STATE OF VERMONT
AGENCY OF TRANSPORTATION

PROPOSED IMPROVEMENT
BRIDGE PROJECT

TOWN OF BRISTOL

RECORD PLANS

Tensioning Blockout Section

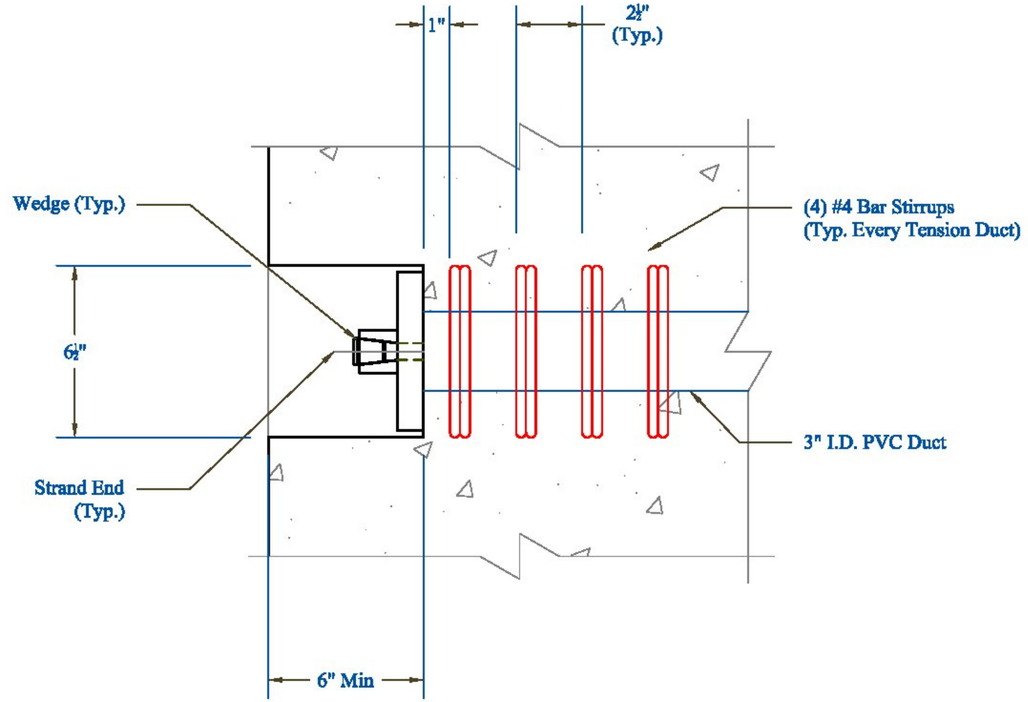
Rev.	Date	By	Description
1	04/16/15	IBA	Changes per State Review

1 F1 PRESTRESSED VOIDED SLAB LAYOUT

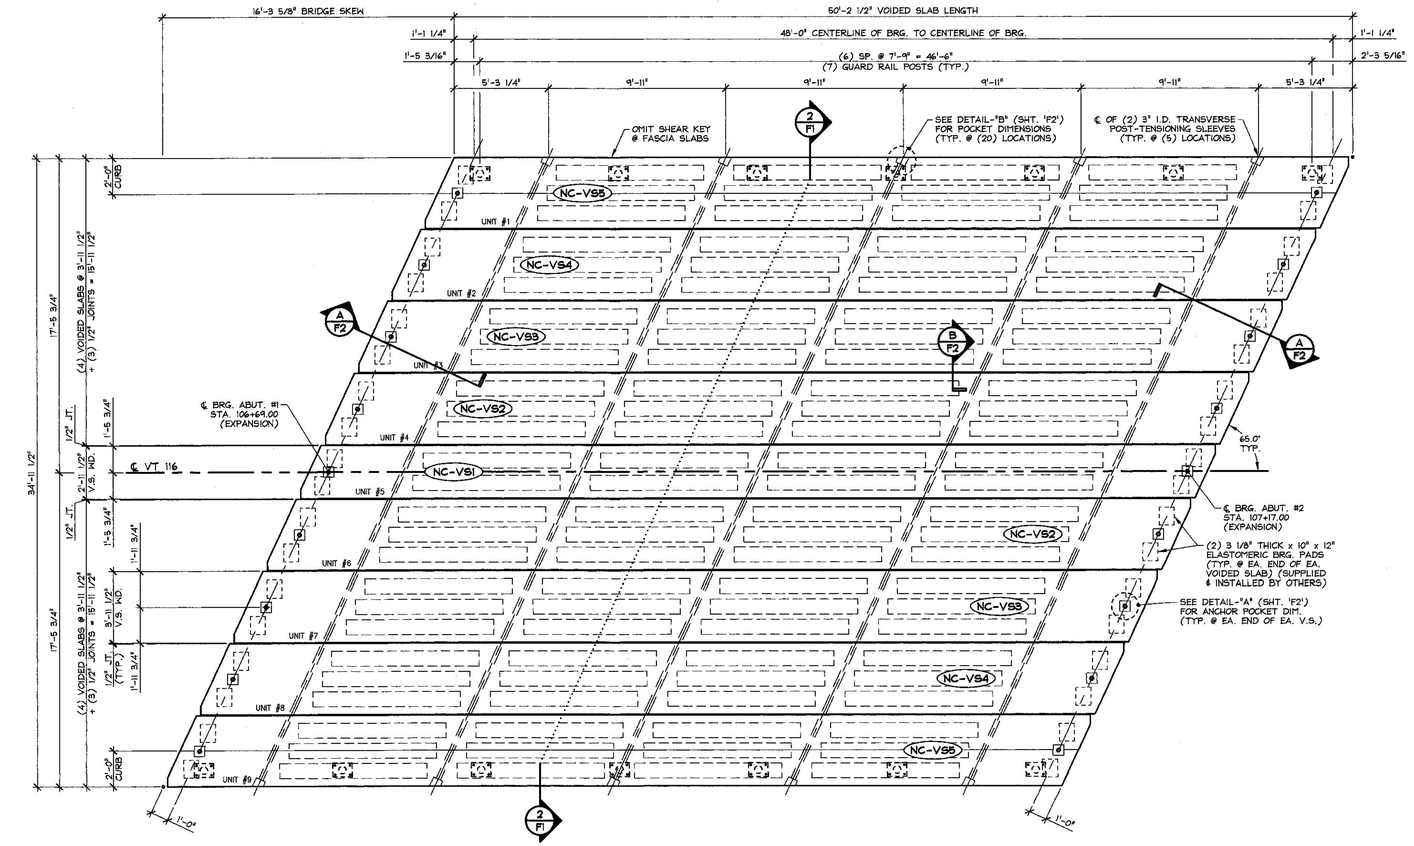
The 2'-0" should be to the outside of the 1" taper, not the inside. Sheet S5 shows it correctly
